Sundry Print Report

Well Name: PRECIOUS 30-18 Well Location: T23S / R31E / SEC 31 / County or Parish/State: EDDY /

## **Notice of Intent**

Type of Action: APD Change

WELL LOCATION AND ACREAGE DEDICATION PLAT

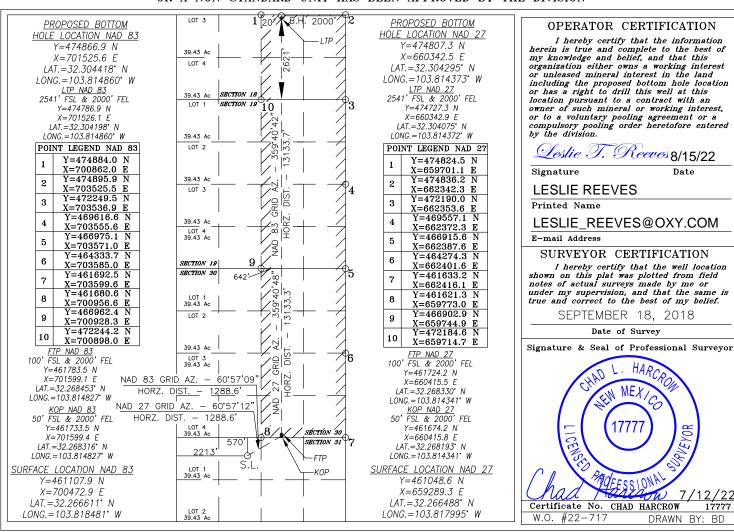
**Procedure Description:** OXY USA Inc. respectfully requests approval to amend the subject well AAPD BHL and drill plan (casing, cementing, mud programs). See the attached updated well plat, directional and drill plan for reference. Old BHL: 2621' FSL 2200' FEL J-18-23S-31E New BHL: 2621' FSL 2000' FEL J-18-23S-31E

UL or lot No.	Section	Townshi	ip	Range	Lot Idn	Feet from the	North/South line	Feet from the	East/West line	County
J	18	23-	S	31-E		2621	SOUTH	2000	EAST	EDDY
Dedicated Acre	s Joint o	r Infill	Cor	nsolidation (	Code Or	der No.				
800
